Report to the Future Melbourne Committee**Agenda item 6.1****Ministerial Planning Referral: TPM-2023-8
54 – 66 La Trobe Street, Melbourne****21 May 2024****Presenter:** Marjorie Kennedy, Head of Statutory Planning**Purpose and background**

1. The purpose of this report is to advise the Future Melbourne Committee of Ministerial planning permit application PA2302293 which seeks amendments to an approved development (Melbourne City Council reference TP-2016-858) for the land at 54 – 66 La Trobe Street, Melbourne (refer Attachment 2 – Locality plan) under section 72 of the *Planning and Environment Act 1987* (Act).

Figure 11 – extract of the TP Response prepared by Bates Smart dated March 2024

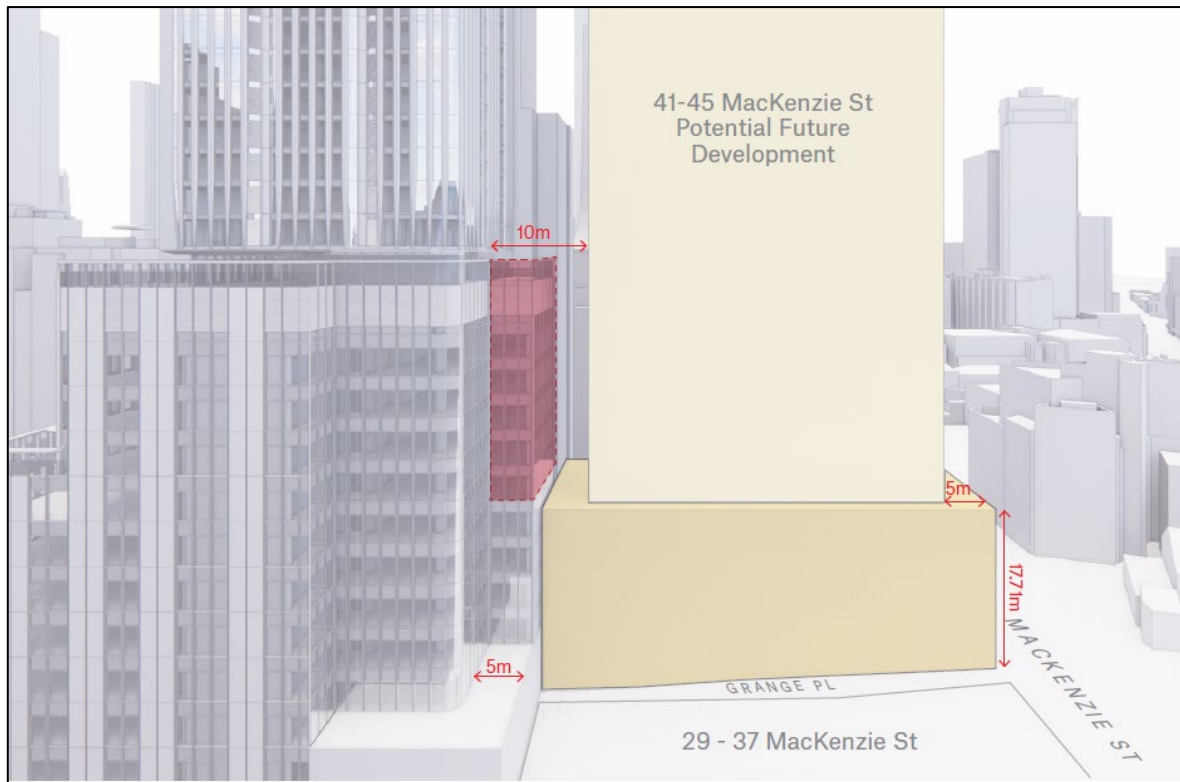
In response, the applicant provided development studies prepared by Bates Smart (see figure 11 below) that identify the development potential of 41-45 MacKenzie Street and propose a five metre setback from level five from the north title boundary. This change, which will be recommended via condition, is considered to provide for an acceptable response to the future development potential of 41-45 MacKenzie Street, the existing podium and tower form of 27-39 MacKenzie Street, and increase the daylight received to these areas.

Figure 12 – extract of the TP Response prepared by Bates Smart dated March 2024

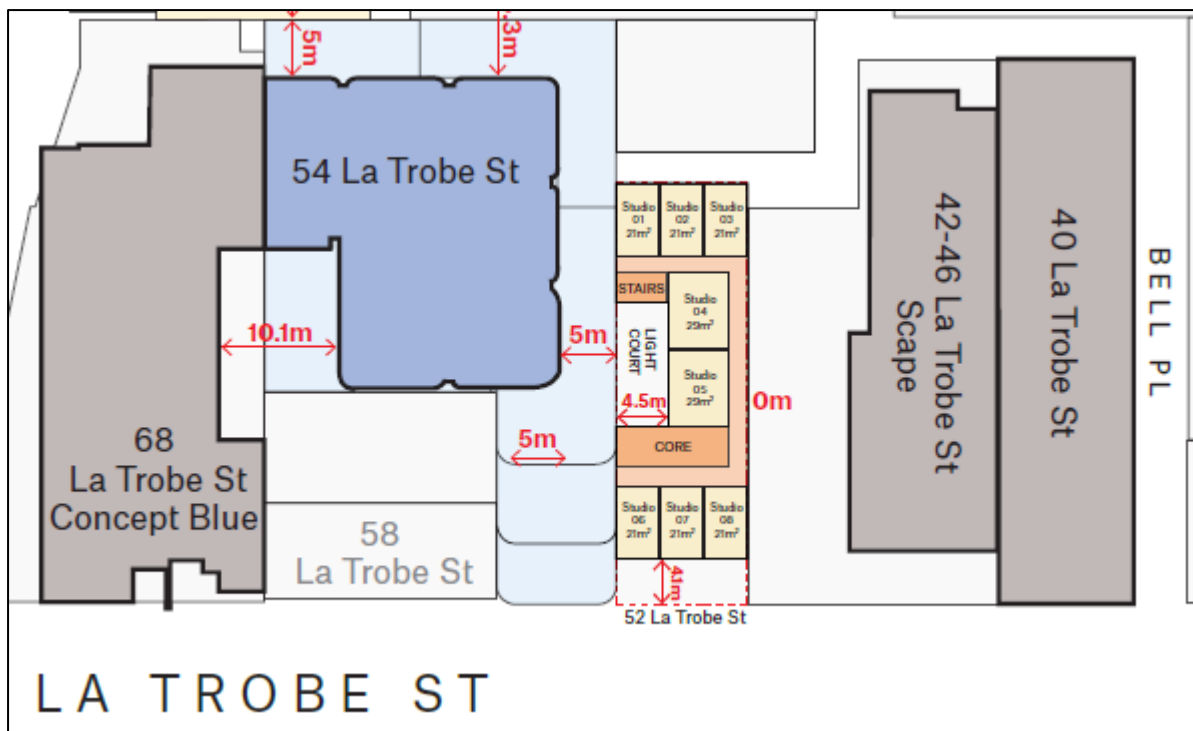
To the east, the proposal includes a five metre setback above the podium which is generally consistent with the existing approval and allows for the reasonable development of 52 La Trobe Street. This outcome allows 52 La Trobe Street to be developed with substantial walls on boundary to the east elevation (it can also do so to the west given an existing wall on boundary) and provide a reasonable setback to respond to the five metres provided by the proposal. The concept of equitable development provides, amongst other things, that larger sites should do their fair share with respect to setbacks. The applicant has provided some diagrams (see an example at figure 12 below) of some potential options of the development of 52 La Trobe Street which confirms that both office and dwellings can be considered on the Site that do not need to rely on an equal five metre setback. A section 173 agreement will be recommended as a condition on permit to require the closure of any openings and windows to this interface to ensure the development rights of 52 La Trobe Street are sufficiently protected.

Figure 16 – extract of the level 12 plan with notations added by the Melbourne City Council

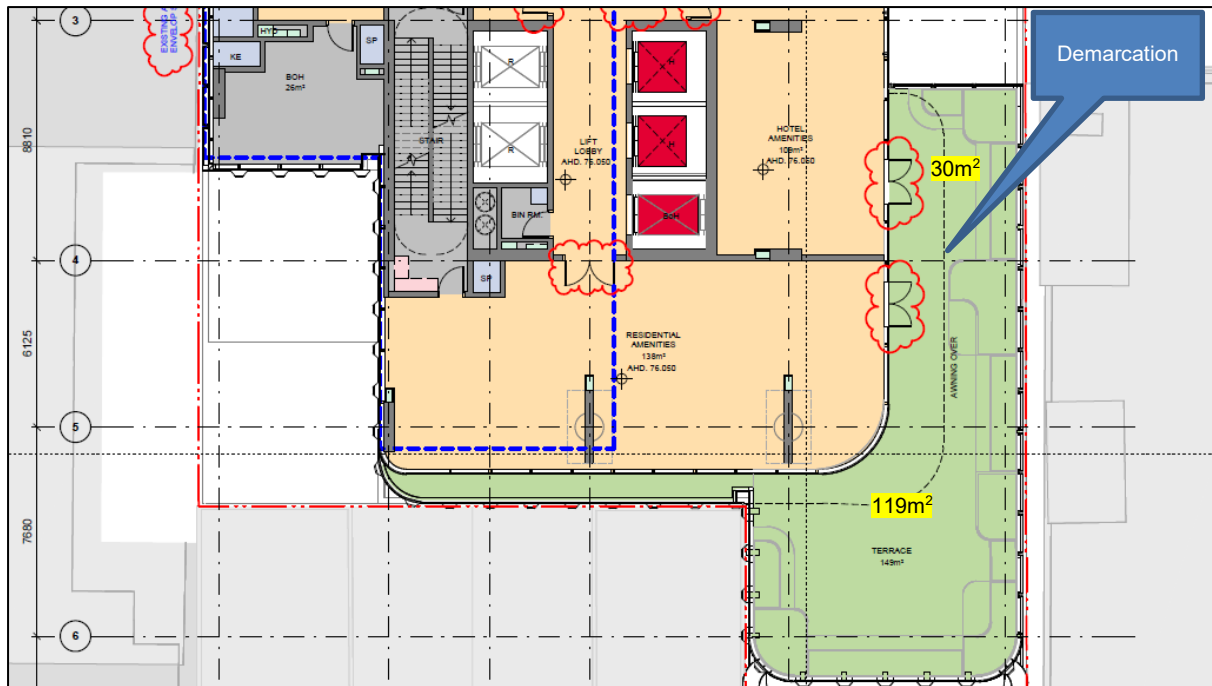
- Standard D7 (Communal open space): the Standard requires 30 m² of communal outdoor open space and an additional space of 2.5 m² per dwelling or 220 m² (whatever is the lesser). With 61 dwellings, the additional space is 155 m². The proposal exceeds this requirement via providing an outdoor area⁴ of 149 m² and an indoor area of 138 m² on level 12 – see figure 16 below. However, given there is no internal separating wall, it appears that the outdoor terrace is shared with the residential hotel which does not make it exclusive for use for the permanent residents. It is recommended via condition that the two areas be demarcated via a wall at the boundary of the indoor hotel amenity area on level 12. This allows an outdoor area for the residential hotel and a terrace area for the apartments that meets Standard D7. There may be other ways to achieve an appropriate outcome.

Figure 20 – extract of the level 4 plan TP03.004

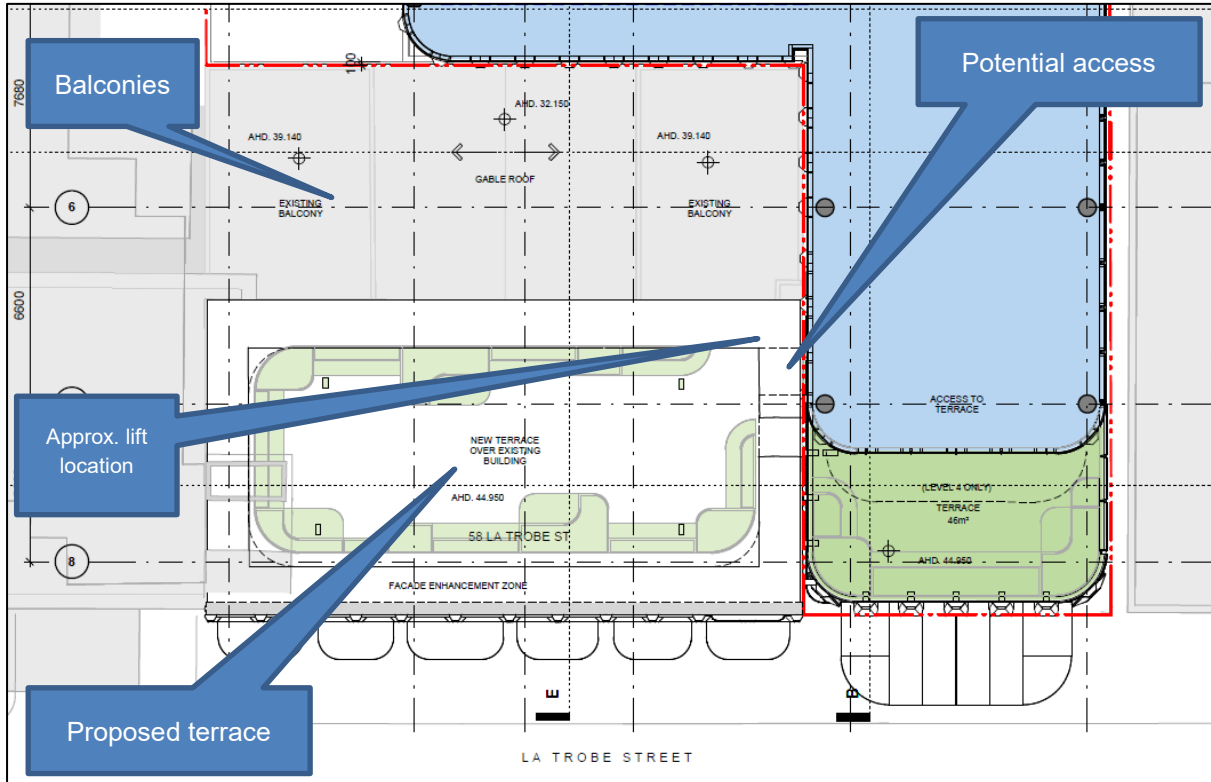
The applicant has confirmed that the terrace is for use by the commercial tenants and will be accessed from the office floor adjacent. There is insufficient detail on the plans in regard to the access arrangements to the terrace and a potential conflict with the existing lift core to the north east of the roof. While the design of the terrace is acceptable noting that it matches the architectural language of the proposed building, as figure 20 below depicts, access to the terrace needs to be carefully considered. It is therefore recommended that DTP request further information on this matter and it is recommended that a condition confirm the access arrangement is free of the lift core.
